DATE: 04.09.2018
TO: ProTrak
FROM: Mitesh Baxi
Traffic Engineering

■ **CORNING CREDIT UNION [TRC Plan Review Rev#3]**

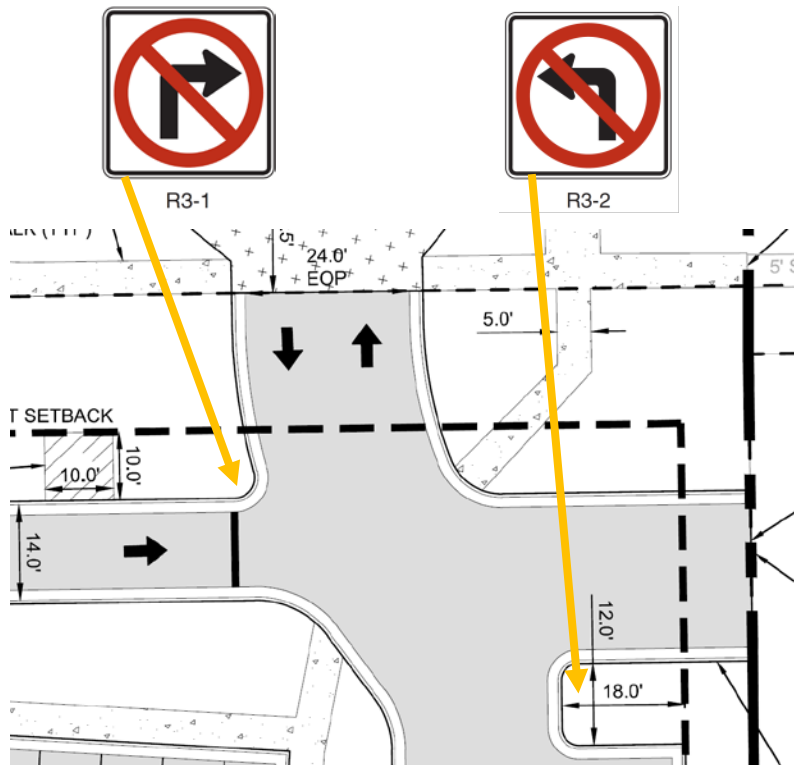
'No Left Turn' sign (R3-2) must be installed before exiting two-way drive aisle, and 'No Right Turn' sign (R3-1) must be installed near the exit of no-way driveway accessing Drive up ATM, facing driveway entrance on Federal Park Dr (see the images below for your reference) in accordance with [MUTCD](#). This is to restrict the egress traffic from turning left and ingress traffic from turning right into one-way drive.
